CITY PLANNING BOARD

BOARD AGENDA

Planning Board Regular Meeting - Tuesday, September 13, 2016 - 6:00 p.m.
City Hall - City Commission Chambers, 100 North U.S. #1, Fort Pierce, Florida

RE: Application for Planned Development (PD)
Mayfair at Lawnwood
1801 Nebraska Avenue

RESTAURANT FLOOR PLAN - 50L

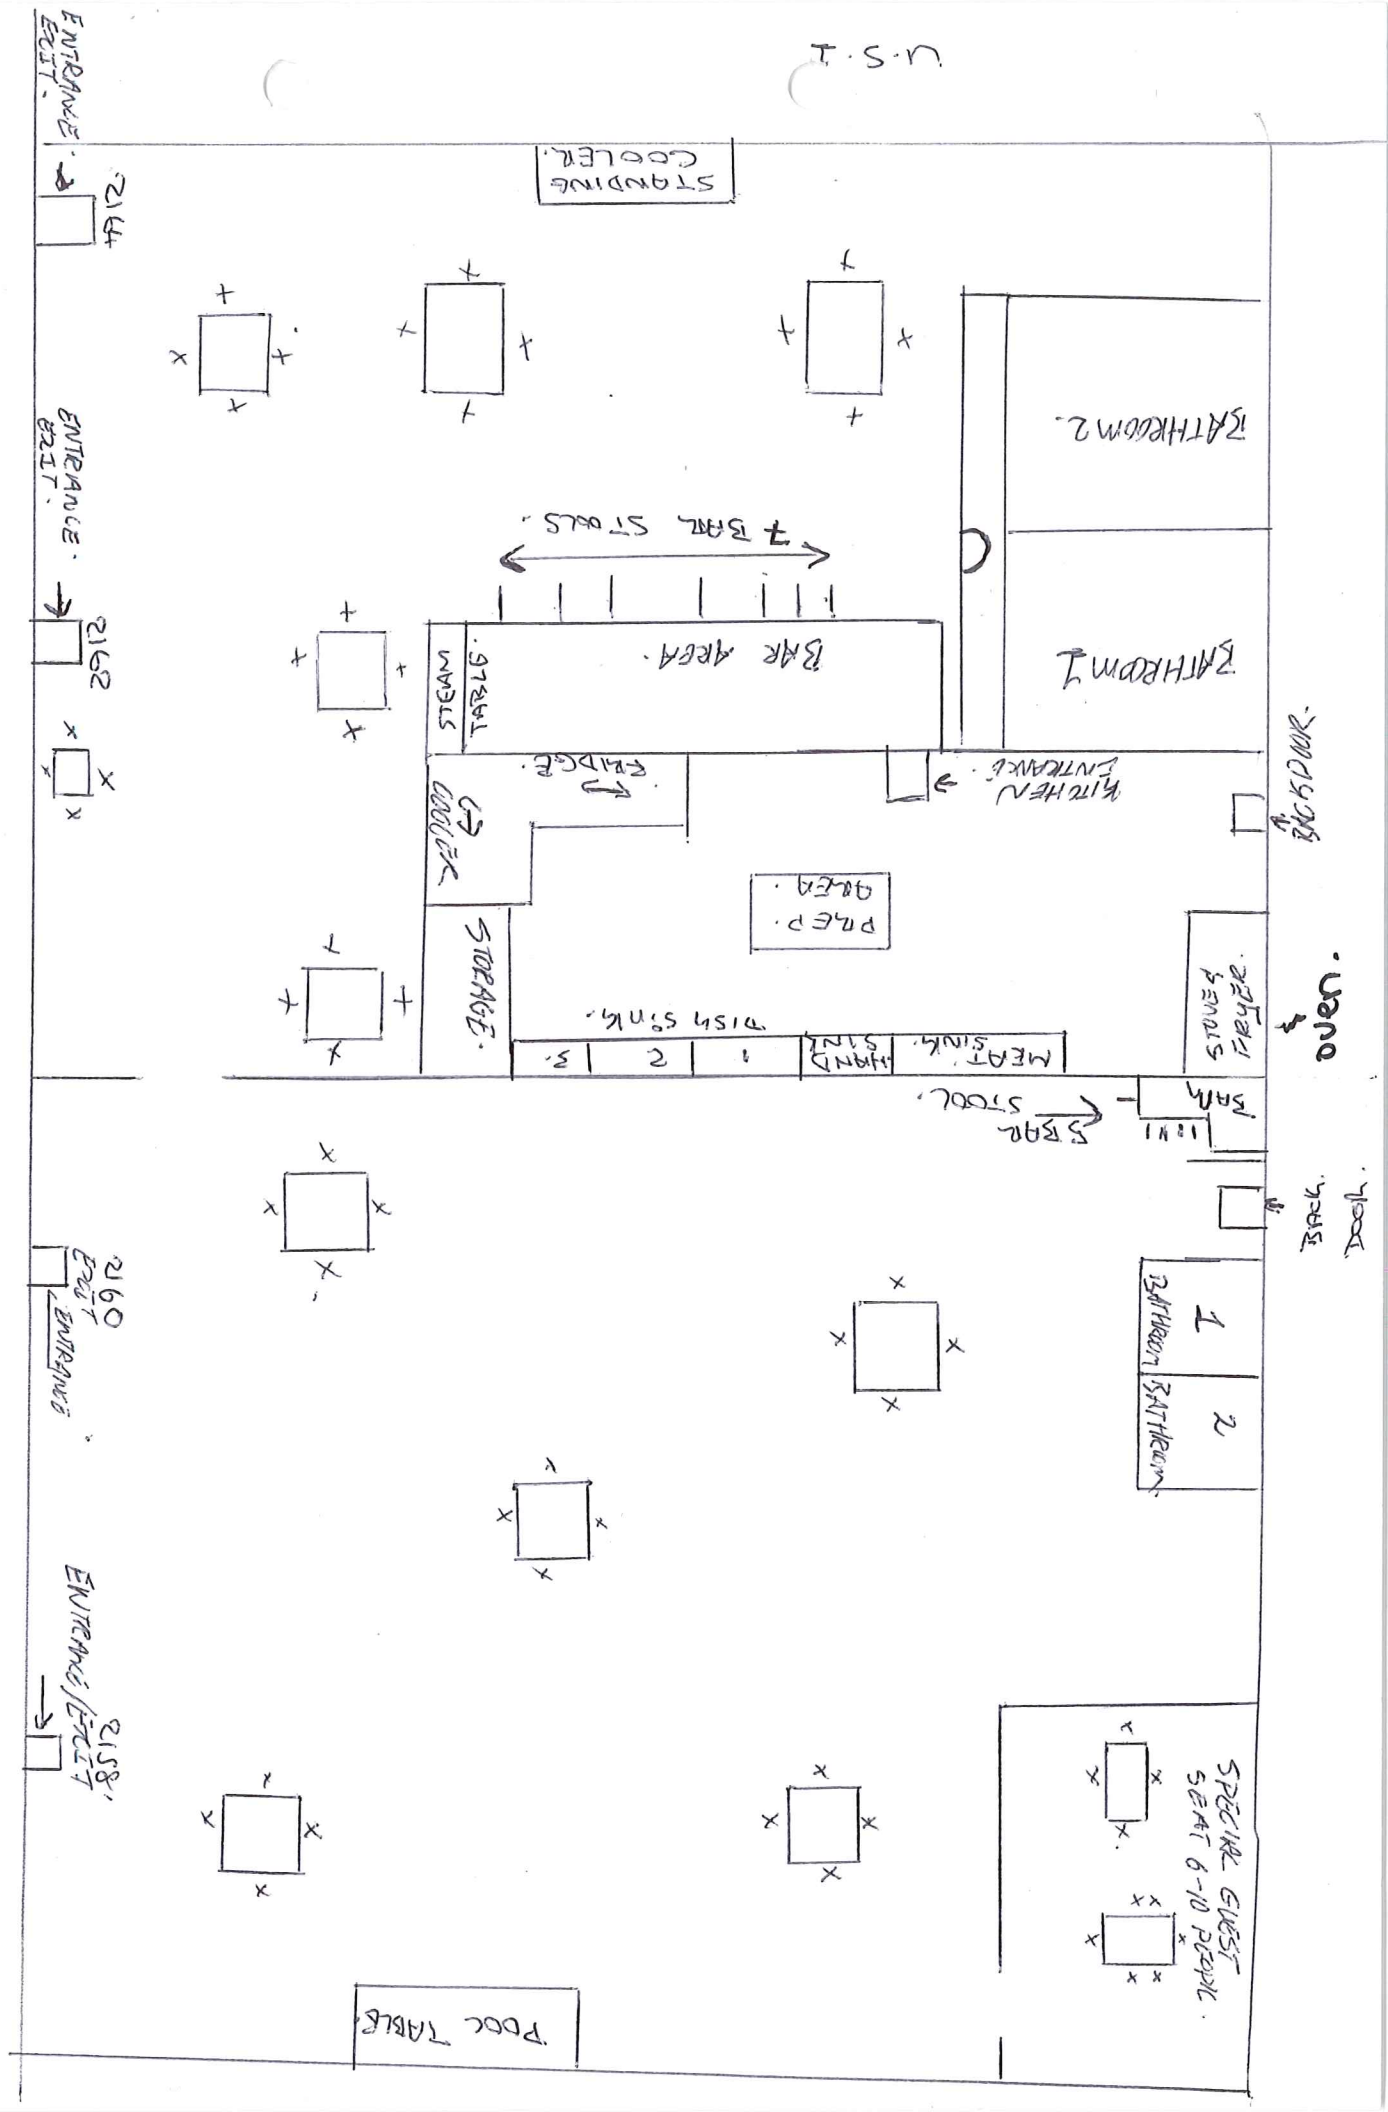
-The presented floor plan does not show the required oven. Please revise the floor plan to meet the minimum requirements for pursuing a 2COP license.

SITE PLAN

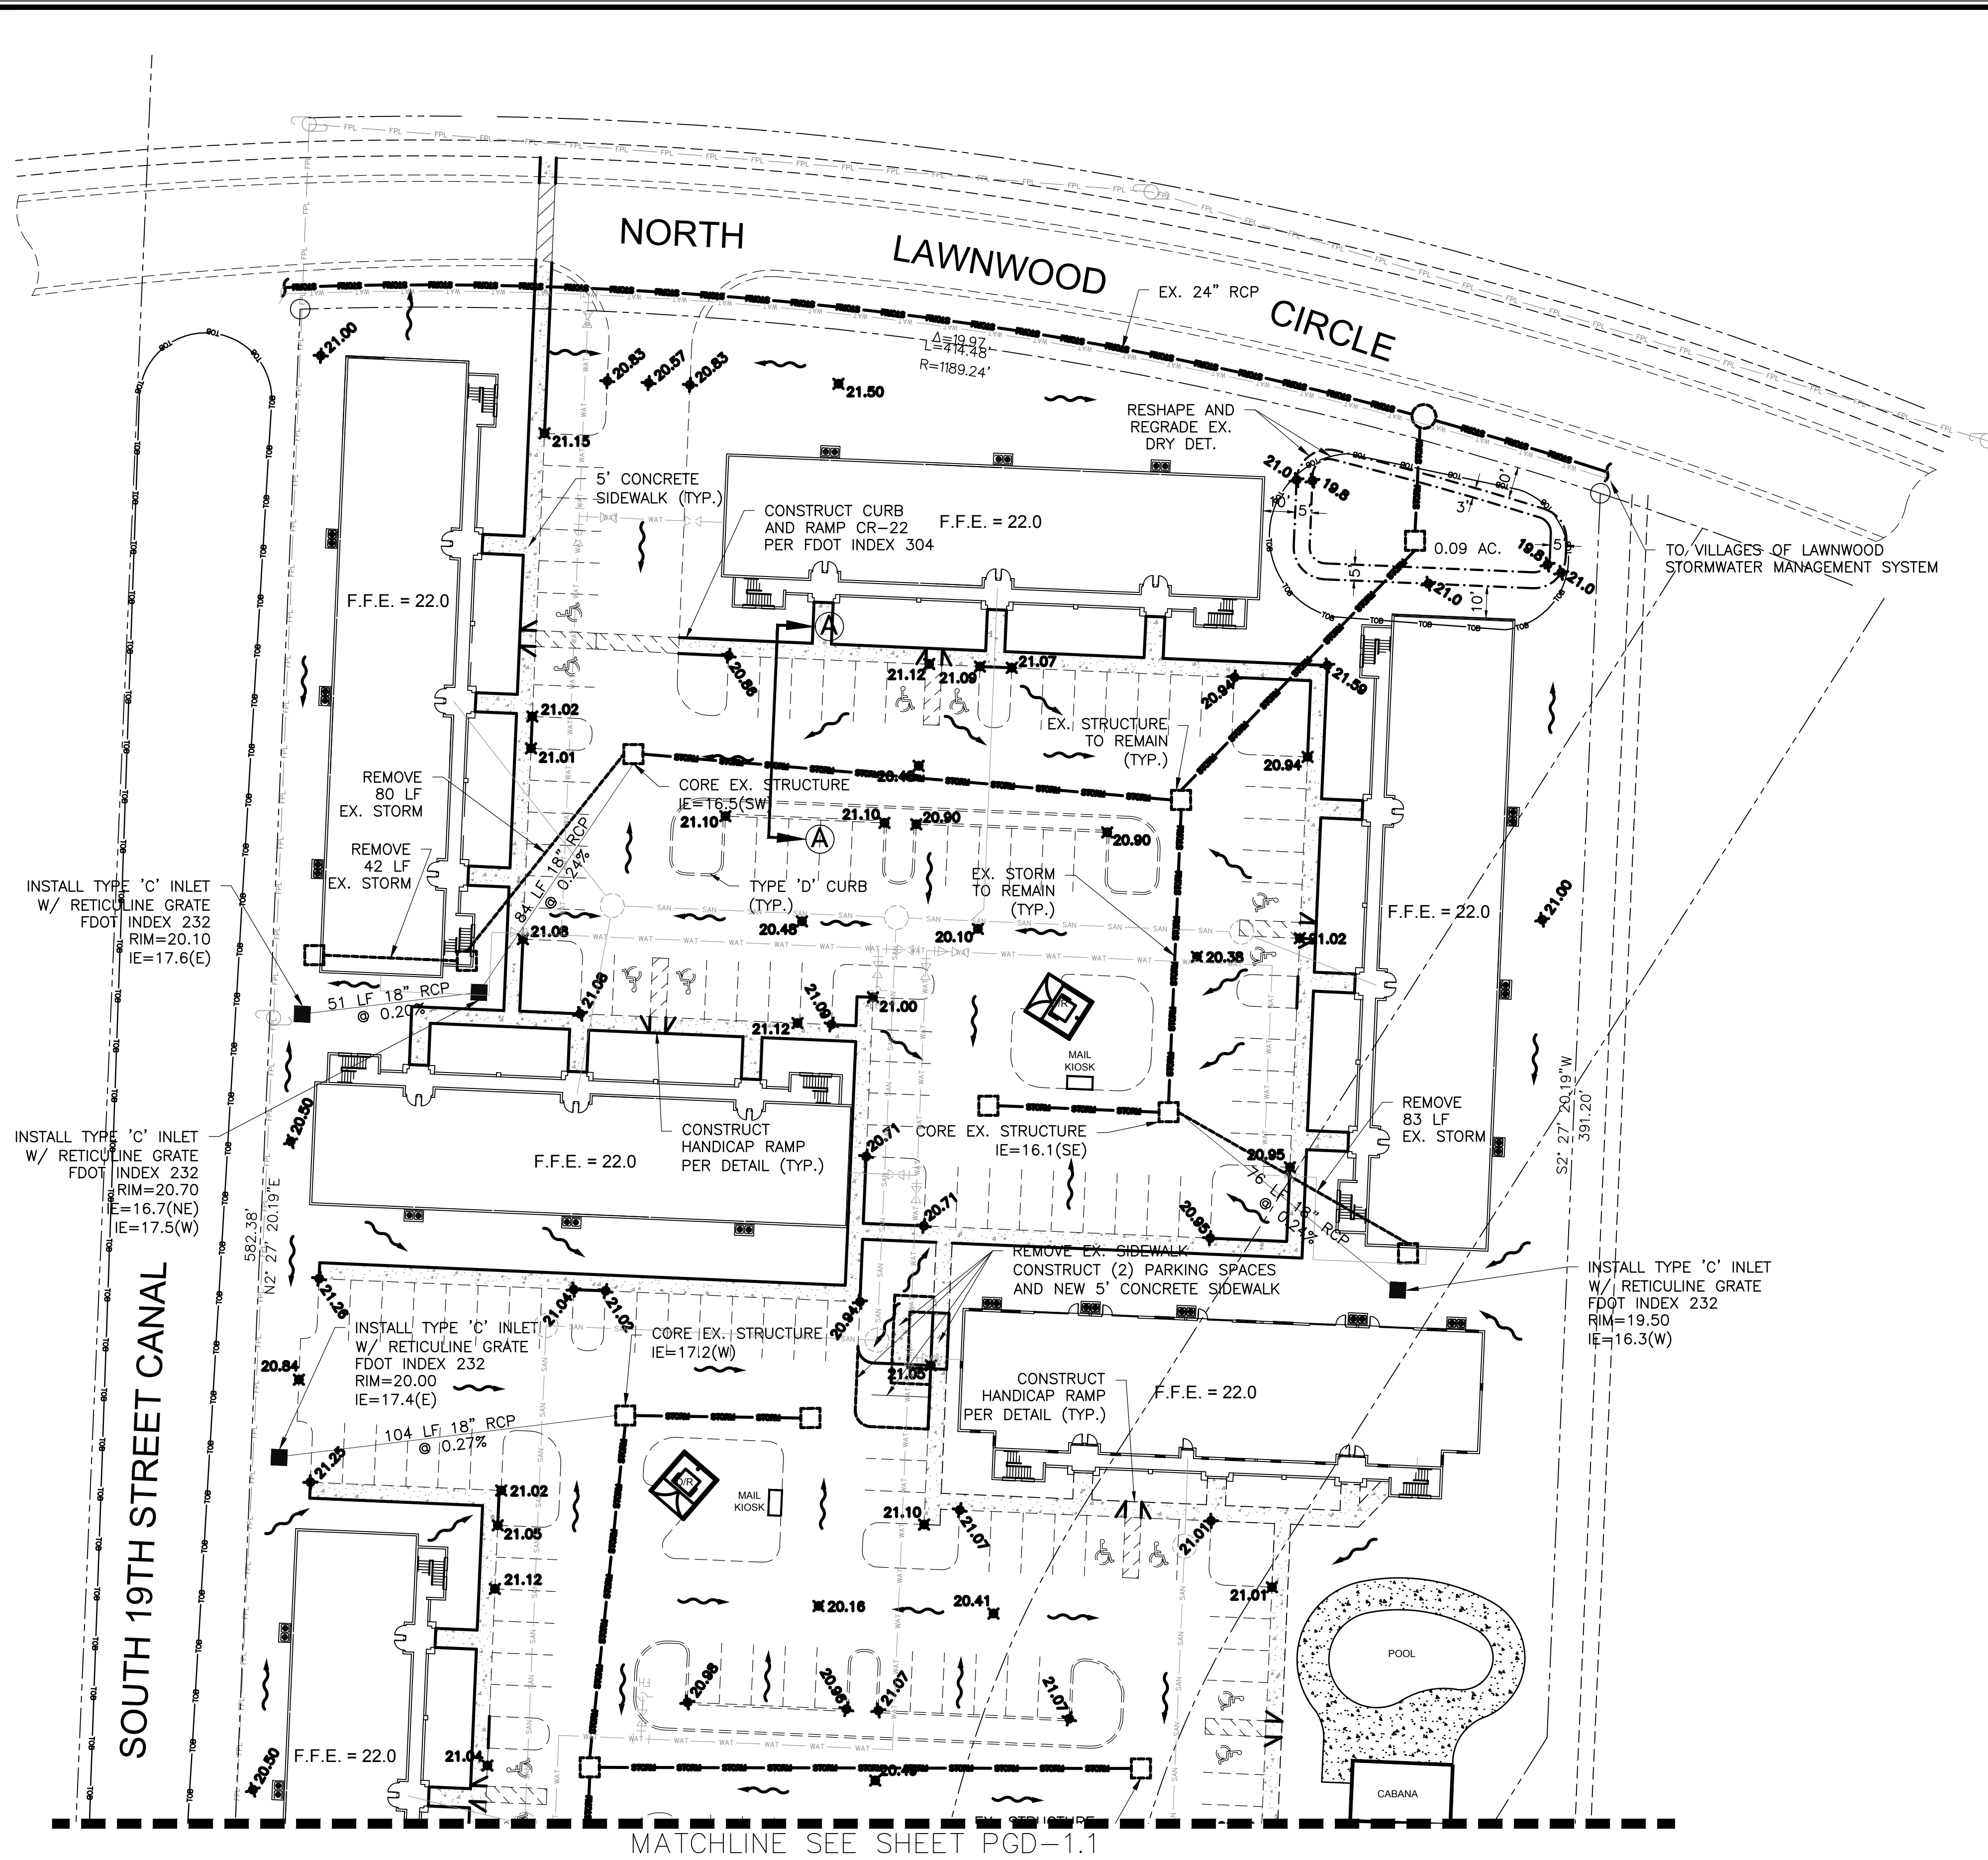
1. Road right of ways abutting the subject parcel are under the jurisdiction of the City of Ft. Pierce. **Advisory comment.**
2. Sheet PGD 1.0; Paving, grading and drainage plan; It is noted that the indicated dimension of 76 LF of 18" RCP scales to be 86'. **Previous comment has been addressed.**

3. Sheet PGD 1.0; Paving, grading and drainage plan; it is noted that the proposed structures have not been identified with a number designation. **Advisory comment.**
